141 FERC ¶ 61,236
UNITED STATES OF AMERICA
FEDERAL ENERGY REGULATORY COMMISSION

[Docket Nos. RM12-6-000 and RM12-7-000; Order No. 773]

Revisions to Electric Reliability Organization Definition of Bulk Electric System and
Rules of Procedure

FINAL RULE

Figure 1
Two Radial Systems Eligible for Exclusion E1

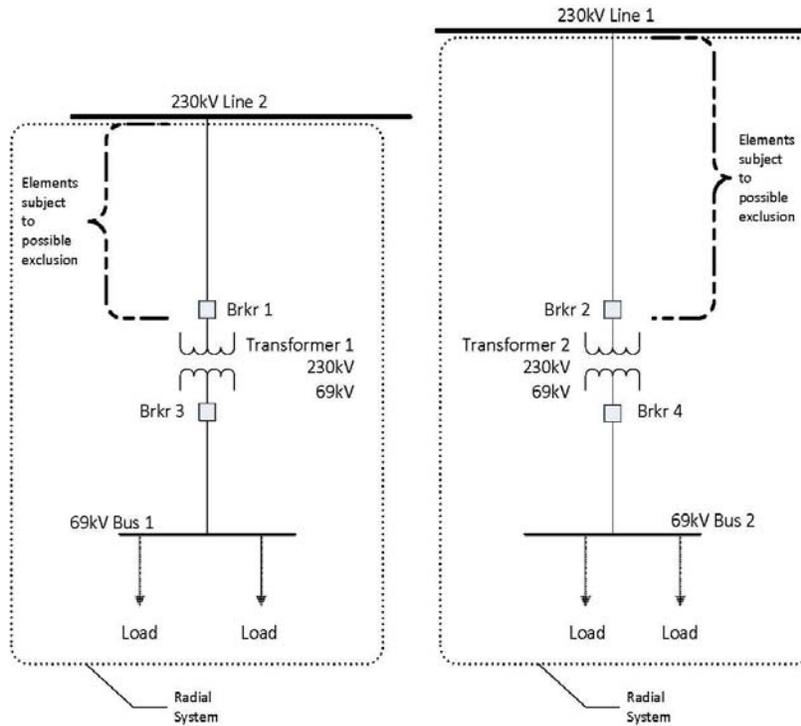
135. NERC and other commenters state that both radial systems depicted in figure 1 would be subject to exclusion E1(a) because they each only serve load.¹²⁶ ELCON agrees with NERC adding that these types of radial systems pose no reliability risk to the interconnected transmission network if the system is lost due to a fault condition. Similarly, SoCal Edison states that the figure 1 facilities would either be excluded or not

part of the bulk electric system. SoCal Edison asserts that, because transformers 1 and 2 each have secondary voltages that are less than 100 kV, they do not meet the inclusion I1 requirements and, thus, are not included in the bulk electric system. In other words, SoCal Edison believes exclusion E1 should exclude all radial facilities that are greater than 100 kV up to the point where “the system is no longer radial, as indicated in figure 1 by the brackets where the 230 kV lines meet [lines 1 and 2].”¹²⁷ APPA believes that all the scenarios described by the Commission could create reliability concerns “if taken in isolation and operated in a certain matter” and believes that the exception process can capture configurations that pose a significant risk to the reliable operation of the interconnected transmission network. Idaho Power maintains that it is inappropriate to apply exclusion E1 for 230 kV elements in the scenarios if the breakers are part of the protection scheme for a three terminal 230 kV line. Idaho Power adds that if either breaker only opens for transformer protection, the exclusion would be applicable.

136. Anaheim agrees that the radials shown in figure 1 should be excluded and requests clarification that the associated bus work and protection system equipment installed on those radial lines are also excluded. Anaheim advocates that the exclusion should also apply to protection system equipment on the excluded facilities that provide backup protection for devices that are part of the bulk electric system, i.e. lines 1 and 2 in figure 1.

140. The Commission agrees with NERC that the radial systems shown in figure 1 meet the definition of “radial system” in exclusion E1. This configuration would result in the 230 kV lines between transformers 1 and 2 to the two 230 kV lines, respectfully, being excluded from the bulk electric system. The Commission agrees with NERC and other commenters that both radial systems depicted in figure 1 would be subject to exclusion E1 condition (a) because they each only serve load.

Figure 2
Networked Configuration w/115 kV Loop

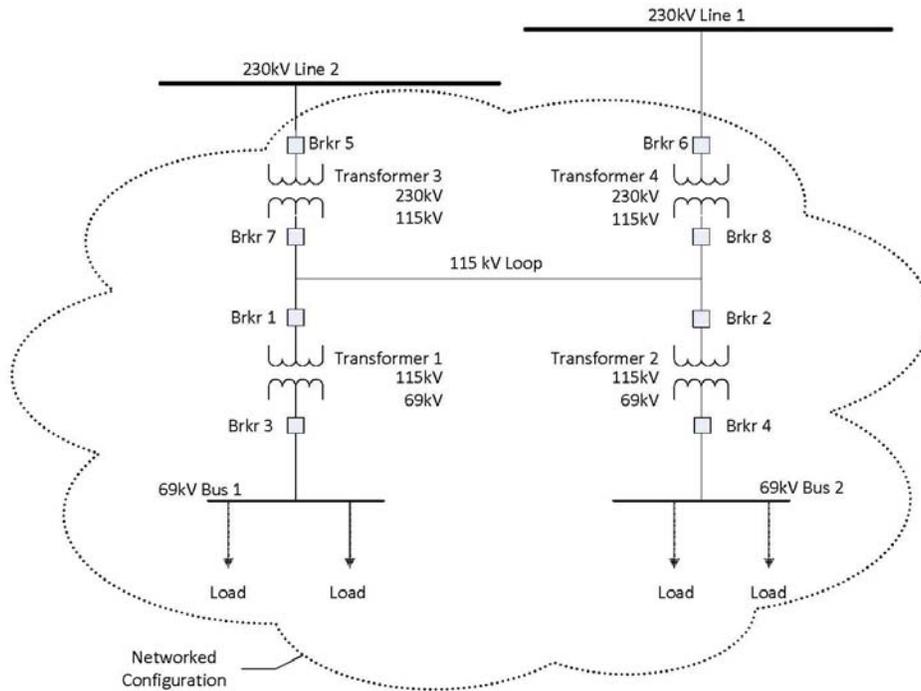
144. In the NOPR, the Commission requested comment on the scenario shown in figure 2 which shows a 115 kV loop, with the configuration emanating from two points of connection of 100 kV or higher. Specifically, the Commission requested comment on whether “the 115 kV and 230 kV elements above Transformers 1 and 2 to the points of connection to the two 230 kV lines would be excluded from the bulk electric system pursuant to exclusion E1.”¹³⁰ The Commission asked for comment on whether it is more appropriate to analyze figure 2 pursuant to the “local network” exclusion E3 and, if so, what if any elements operated at or above 100 kV would be excluded pursuant to exclusion E3.

145. NERC states that figure 2 is a non-radial loop on the 115 kV system. According to NERC, the 115 kV elements above transformers 1 and 2 to the point of interconnection with lines 1 and 2 would not be eligible for exclusion E1 because they do not emanate from a single point of connection. NERC also states that it would be appropriate to evaluate figure 2 under exclusion E3 as a potential local network.¹³¹ For such a

146. Likewise, Idaho Power, ITC Companies, and National Grid contend that the figure 2 configuration should be included in the bulk electric system. Southern Companies believe exclusion E1 may apply from the breakers down and that the configuration may belong to exclusion E3. AEP assumes that each of the facilities below the 115 kV loop shown in figure 2, and including breaker 1 and breaker 2, are radial and excluded pursuant to exclusion E1. According to AEP, the facilities above breakers 1 and 2 may be excluded pursuant to exclusion E3 depending on the circumstances.¹³³

147. Valero states that the figure 2 configuration is very similar to common facilities configurations employed in many industrial facilities involving the interconnection of the industrial facility to the utility through two high voltage feeder lines that originate at different utility owned and operated substations. Valero requests that the Commission include in the final rule an additional exclusion that would “categorically exclude from the [bulk electric system] any on-site high voltage switchyard facilities (less than 300 kV) owned by the industrial end-user where the predominant function of the facilities is to

distribute electricity in an inward direction to the end-user's load."¹³⁴ WPPC argues that figure 2 shows both radial and network systems and that the system from the 115 kV loop upwards would be assessed under exclusion E3 and below that point would be assessed by exclusion E1.

148. The Commission affirms NERC's statement that figure 2 is a non-radial loop and thus would not be eligible for exclusion E1 because it does not emanate from a single point of connection. The Commission agrees with commenters that the elements below the 115 kV loop should be assessed as two separate radial systems pursuant to exclusion E1. The remaining elements (the 115 kV loop, transformers 3 and 4 and the 230 kV tie lines above the transformers to the two 230 lines 1 and 2) should be assessed pursuant to exclusion E3 and if the configuration meets the criteria of exclusion E3, the elements could be excluded.

Figure 3
Networked Configuration w/69 kV Loop

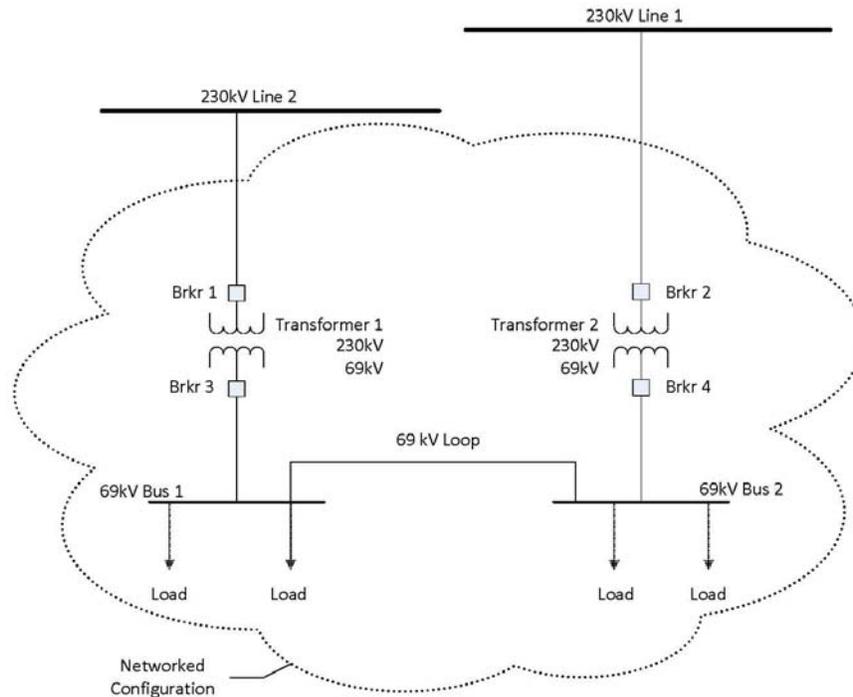
150. In the NOPR, the Commission agreed with NERC's proposal that radial systems only serving load and emanating from a single point of connection of 100 kV or higher should be excluded from the bulk electric system. However, the Commission expressed concern "that the exclusion could allow elements operating at 100 kV or higher in a configuration that emanates from two or more points of connection "to be deemed "radial" even though the configuration remains contiguous through elements that are operated below 100 kV."¹³⁵ Figure 3 in the NOPR illustrated this concern, and the Commission asked for comment on how to evaluate the configuration relative to the radial system definition. The Commission also requested comment on the appropriateness of examining elements below 100 kV to determine if the configuration meets exclusion E1, i.e., whether figure 3 depicts "a system emanating from two points of connection at 230 kV and, therefore, the 230 kV elements above the transformers to the points of connection to the two 230 kV lines would not be eligible for the exclusion E1 notwithstanding the connection below 100 kV."¹³⁶

151. NERC disagrees with the Commission's characterization of figure 3 in the NOPR. NERC states that figure 3 does not depict a configuration with two points of 100 kV or higher or a system emanating from two points of connection at 230 kV. According to NERC, except for lines 1 and 2, all the other elements depicted in figure 3 are excluded from the bulk electric system. NERC explains that the elements between line 1 and transformer 2 and from line 2 to transformer 1 are excluded by exclusion E1(a) because "each separate set of [e]lements [described above] is contiguous and emanate from a

153. Exelon agrees with NERC and explains that it has many connections similar to the one shown in figure 3 and provides a specific example where a 138 kV substation is fed by two radially connected 138 kV lines which in turn are connected through 40 MVA transformers to a 12 kV bus section. Exelon states that in its example the 40 MVA transformers cross bus sections so that if one of the 138 kV lines is out of service, each side of the 12 kV bus retains service. Exelon believes that due to the high impedance of the transformers, little energy flows between the buses in Exelon’s example.¹³⁸ Exelon

154. Other commenters believe that the figure 3 configuration may not be eligible for exclusion E1. SoCal Edison explains that the 69 kV loop is not open and therefore is a parallel path to the 230 kV system. BPA, Alameda and WREA do not view the figure 3 system as eligible for exclusion E1 because the system is networked. Idaho Power states that the 230 kV lines would be included only if there is a protection system in place for the 230 kV lines. According to Idaho Power, the elements above the transformers in figure 3 would not be excluded from the bulk electric system. Idaho Power believes this configuration should be evaluated under exclusion E3.

155. The Commission finds figure 3, which is identical to figure 5, is a networked configuration through a 69 kV loop and does not qualify for exclusion E1. The Commission also finds that, because the load in figure 3 can be served by either 230 kV line, it does not depict a “radial system.” However, the facilities below 100 kV may or may not be necessary for the operation of the interconnected transmission network, and this decision can be made case-by-case in the exception process. In other words, such facilities below 100 kV depicted in figure 3 would be excluded under the general threshold of the core definition unless found on a case-specific basis as necessary for the reliable operation of the interconnected transmission network. Thus, the Commission, while disagreeing with NERC’s interpretation, does not propose to include the below 100 kV elements in figure 3 in the bulk electric system, unless determined otherwise in

the exception process. Further, as we discuss below in connection with exclusion E3 and figure 5, while we find that the configuration shown in figures 3 and 5 would not be eligible for exclusion E1, we believe that such configurations should be eligible for exclusion E3 for local networks. However, exclusion E3 as written requires the candidate local network to be contiguous and above 100 kV, thus, the exclusion E3 language as written does not allow for figures 3 and 5 to be eligible for the local network exclusion because they are not contiguous *and* include facilities that are not above 100 kV. Therefore, we direct NERC to modify exclusion E3 to remove the 100 kV minimum operating voltage in the local network definition. This modification will enable configurations similar to figures 3 and 5 to be assessed for the local network exclusion. The Commission believes this modification, together with satisfying the criteria outlined in exclusion E3, will appropriately exclude local network configurations that are not necessary to the reliable operation of the interconnected transmission network.¹³⁹

Figure 5
Networked Configuration w/69 kV Loop

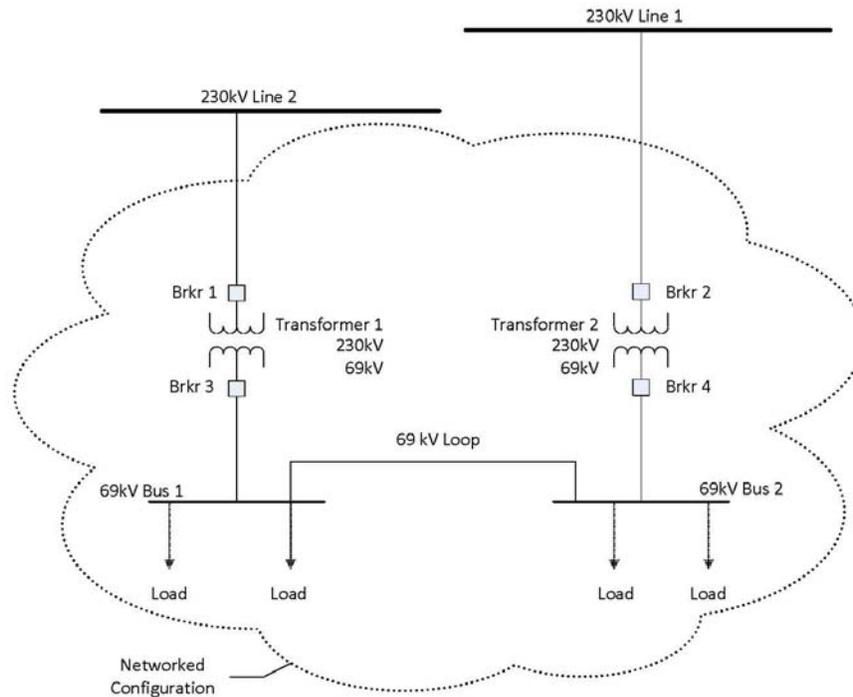
195. In the NOPR, the Commission stated that figure 5 depicts a group of elements that are contiguous through a 69 kV loop and requested comment whether the configuration in figure 5 qualifies as a local network and, in particular, whether the configuration satisfies the conditions that a local network be contiguous and operated at or above 100 kV.

196. NERC views figure 5 the same as figure 3 - as a looped system below 100 kV - that is not considered under this exclusion because the elements below 100 kV are

presumed to be not part of the bulk electric system.¹⁶⁷ NERC maintains that, if it is determined that the sub-100 kV looped system is necessary for the reliable operation of the interconnected transmission network, the exception process may be utilized to include the appropriate elements. NERC states that figure 5 depicts two separate and distinct groups of elements that each emanate from a single point of interconnection at 230 kV and only serve load. Accordingly, NERC states that 230 kV lines 1 and 2 are included in the bulk electric system with the only other included elements being the lines extending from lines 1 and 2. However, according to NERC, the elements between 230 kV line 1 and transformer 2 and between 230 kV line 2 and transformer 1 are each subject to exclusion E1(a) because each separate set of elements is contiguous and emanate from a single point of connection of 100 kV or higher. NERC asserts that the elements below the 69 kV side of transformers 1 and 2 are excluded because they are less than 100 kV. NERC explains that transformers 1 and 2 are excluded because they bridge voltages of 69 kV and 230 kV and therefore, inclusion I1 is not applicable because a transformer must have two terminals over 100 kV to qualify for inclusion I1. According to NERC, the definition should focus on looped or networked connections at 100 kV or greater because such connections, when operated below 100 kV, generally do not carry

197. Exelon states that the clear intent of the definition is that configurations such as shown in figure 5 are radial systems subject to exclusion E1 (radial systems). According to Exelon, had this not been the intent of exclusion E1, exclusion E3 would have allowed for a local network where the tie was below 100 kV to avoid a reliability gap. Exelon believes that the configuration shown in figure 5, which is identical to figure 3, does not qualify as a local network within the terms of exclusion E3 and supports NERC's view that figure 5 represents two radial systems that qualify under exclusion E1. Exelon cautions that, if the Commission determines that the systems depicted in figure 5 do not qualify under exclusion E1 because of the low voltage tie and does not qualify under exclusion E3 because the tie is at low voltage and not a 100 kV or above, such a decision would leave a gap under which a substantial number of facilities that are not part of the bulk electric system would be classified as such. Exelon states that it would have to go through the separate exception process for dozens of substations, at great cost and for no useful purpose. Exelon states that the Commission should clarify that the configuration shown in figures 3 and 5 qualifies as a radial system and is excluded pursuant to exclusion E1.

199. As discussed above, the Commission is directing a modification to exclusion E3 to better capture local networks like those depicted in figure 5. The Commission notes that Exelon believes that the configuration shown in figure 5, which is identical to figure 3, does not qualify as a local network within the terms of exclusion E3. While figures 3 and 5 are a networked configuration through a 69 kV loop, they do not qualify for the local network exclusion because exclusion E3 defines local networks as “[a] group of contiguous transmission Elements operated at or above 100 kV but less than 300 kV that distribute power to Load rather than transfer bulk-power across the interconnected system.” The configuration in figure 5 includes elements that are below 100 kV, and does not have contiguous elements operating at or above 100 kV but less than 300 kV. As noted above, while the Commission finds that these configurations should not be eligible for exclusion E1, we believe that they should be eligible for the local network exclusion. Therefore, we direct NERC to modify exclusion E3 to remove the 100 kV minimum operating voltage in the local network definition. Within 30 days of the effective date of this Final Rule, we direct NERC to submit a schedule outlining how and when it will make the modification to the definition.
